STAFF RECOMMENDATION
4205 Elkins Avenue
September 18, 2019

Application: New Construction—Addition
District: Park and Elkins Neighborhood Conservation Zoning Overlay
Council District: 24
Base Zoning: RS7.5
Map and Parcel Number: 091160L00100CO and 091160L00200CO
Applicant: Brad Bars
Project Lead: Melissa Sajid, melissa.sajid@nashville.gov

Description of Project: Application is to construct a rear addition. No changes to the historic house are proposed.

A HORIZONTAL PROPERTY REGIME OF
 THE BRADLEY J. BARS PROPERTY
 24TH COUNCIL DISTRICT
 NASHVILLE, DAVIDSON COUNTY TENNESSEE
 APRIL 17, 2019

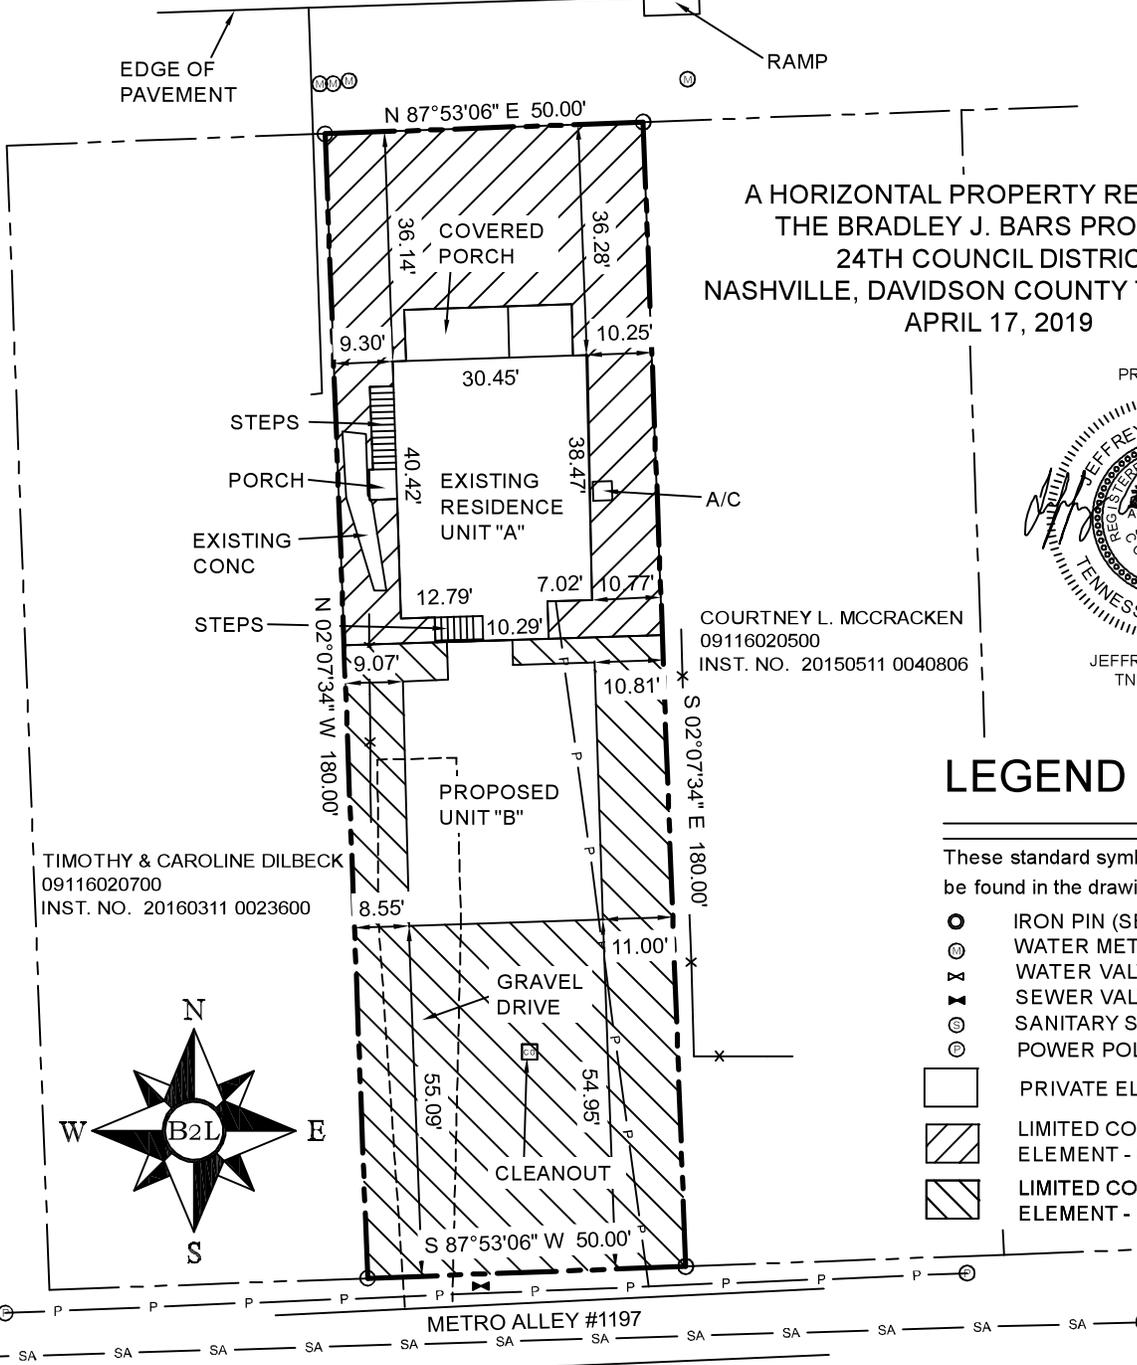
Setback & Rhythm of Spacing: The addition is located approximately nine feet (9') from the right-side property line, ten feet, ten inches (10'-10") from the left-side property line, and fifty-five feet (55') from the rear property line. As proposed, the addition meets all base zoning setbacks.

RIGHT SIDE ELEVATION

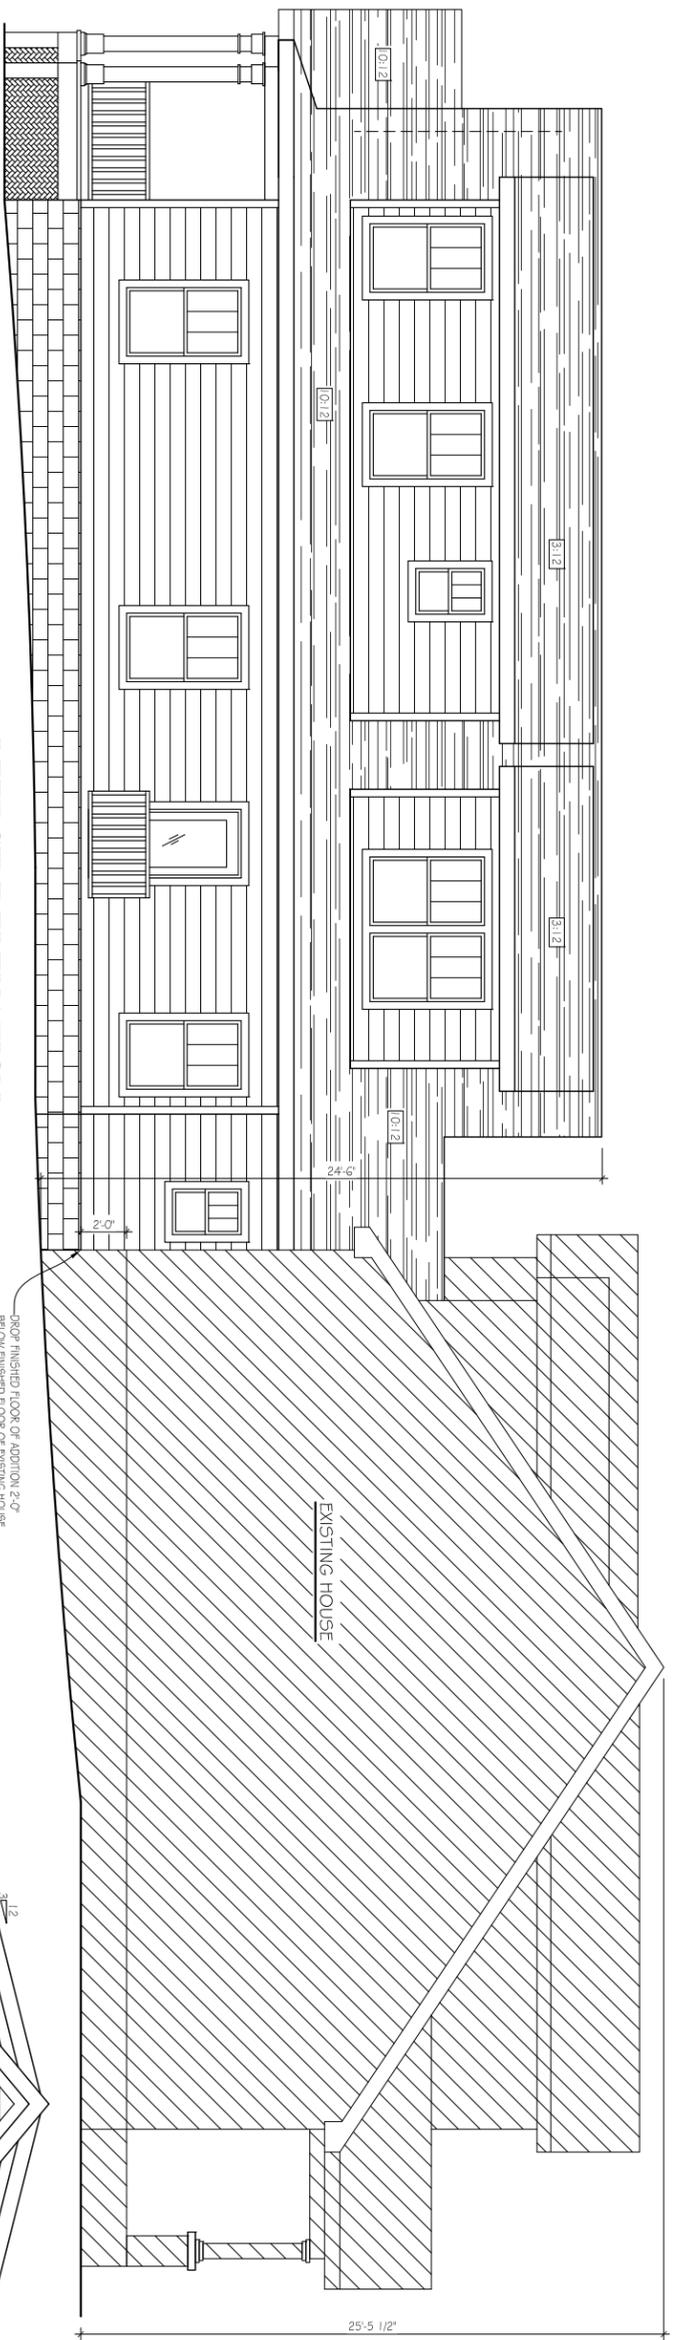
1. The dormers on the right-side facade of the addition shall incorporate additional glazing, and the windows shall be vertically oriented;
2. Staff approve all materials prior to purchase and installation; and
3. The HVAC shall be located behind the house or on either side, beyond the midpoint of the house, and utility meters shall be located on the sides or rear of the building. Alternative mechanical and utility locations must be approved prior to an administrative sign-off on building permit(s).

Proportion and Rhythm of Openings: No changes to the window and door openings on the existing house were indicated on the plans. Most of the windows on the proposed addition are generally twice as tall as they are wide, thereby meeting the historic proportions of openings. There are two horizontally oriented transom windows proposed on the dormers on the right-side façade of the addition. Staff finds that the proportion of these windows do not meet the design guidelines. In addition, the front wall of dormers should be primarily glazing. Staff recommends that the dormers on the right-side facade of the addition incorporate more glazing and that the windows be vertically oriented. With this condition, staff finds the project's proportion and rhythm of openings to meet Section II.B.1.g.
